Request for Class II Permissive Change(C2PC)

FCC ID: VG8XM136AYYW-PV5

This is a C2PC application for which the previous grant was issued on 2022-11-07.

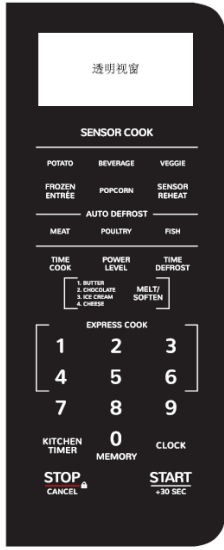
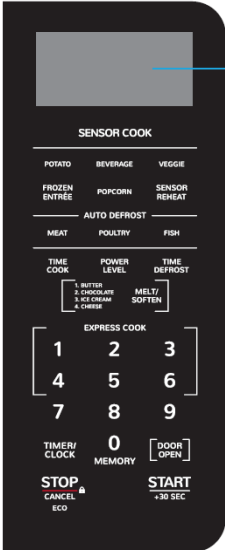
No.:	Original	New	Difference(s)
1			Keypad: Updated front keypad to accommodate child lock function (Child resistant oven door function).
2			Mother board: Modified the peripheral circuit (non-RF circuit) and some individual components and PCB layout. The magnetron and other circuit are exactly same as before.
